Report Type: CC Access Report
Reference Number: 19064A
Client: Complete Urban
Site Address: Colyton Neighbourhood Centre

ACCESS REPORT

This Access Compliance Report is to accompany a Construction Certificate Application for the development proposed at Colyton Neighbourhood Centre.

This development proposes Additions and Alterations to an Existing building for a Community Centre facility. The development is within Penrith City Council LGA.

Areas that are required to comply with access requirements under the Access to Premises Standards.

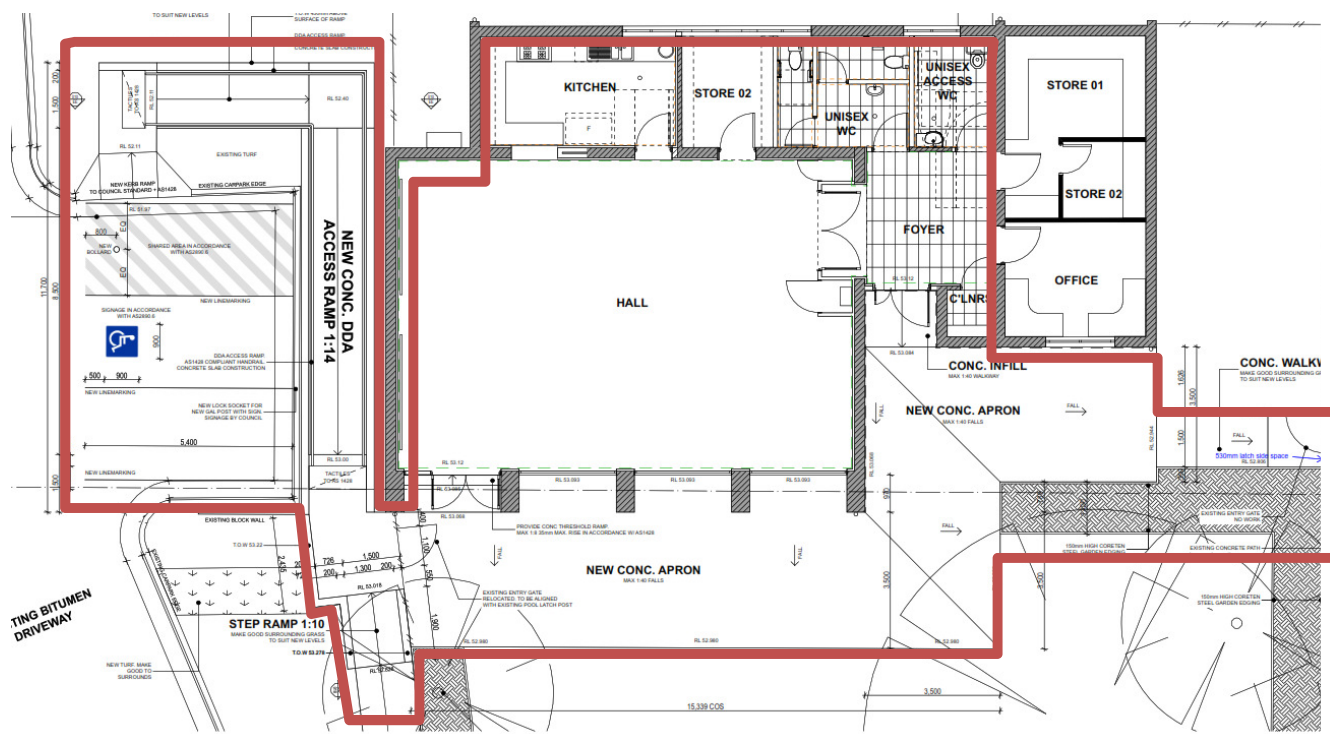
Compliance Comments	<p>Capable of compliance.</p> <p>As stated in the above requirements, APS only applies to,</p> <ul style="list-style-type: none"> - New works, - Modified works and - Works within the 'affected part' <p>In this development, the new works, modified works and works within the 'affected part' have been shown in the plan below with a red boundary.</p>

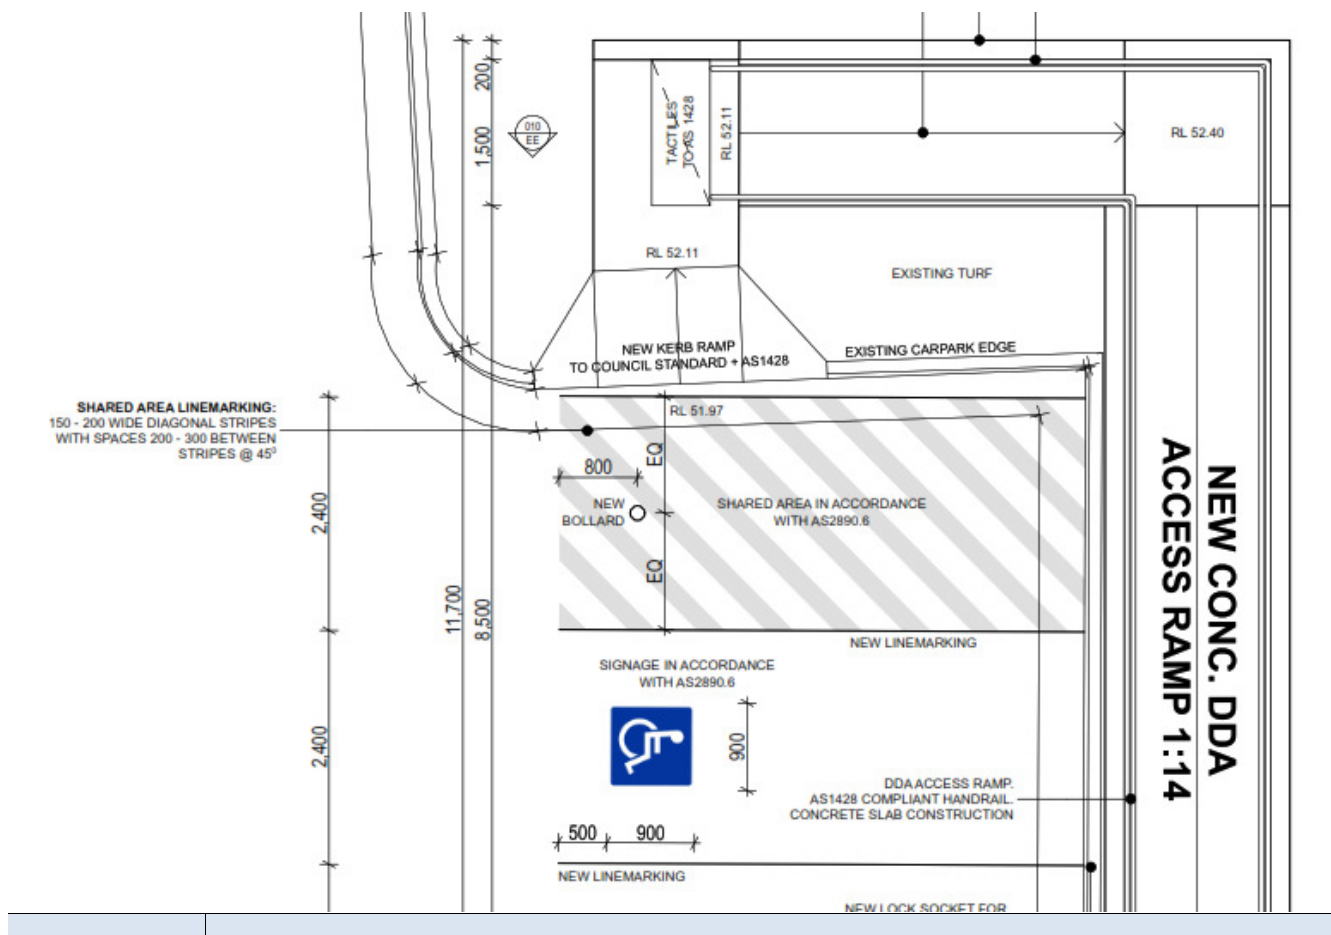
BCA Part D3.5 Accessible Carparking
Requirement	Class 9b School - 1 Accessible car parking space per 100 spaces provided Other assembly building - 1 Accessible car parking space per 50 spaces provided and then additional 1 Accessible car parking space per additional 100 spaces provided
Compliance Comments	Complies. Total number of Accessible parking spaces required / provided in the development = 1

The Accessible parking, shared zones, linemarking and bollards to be as shown above.
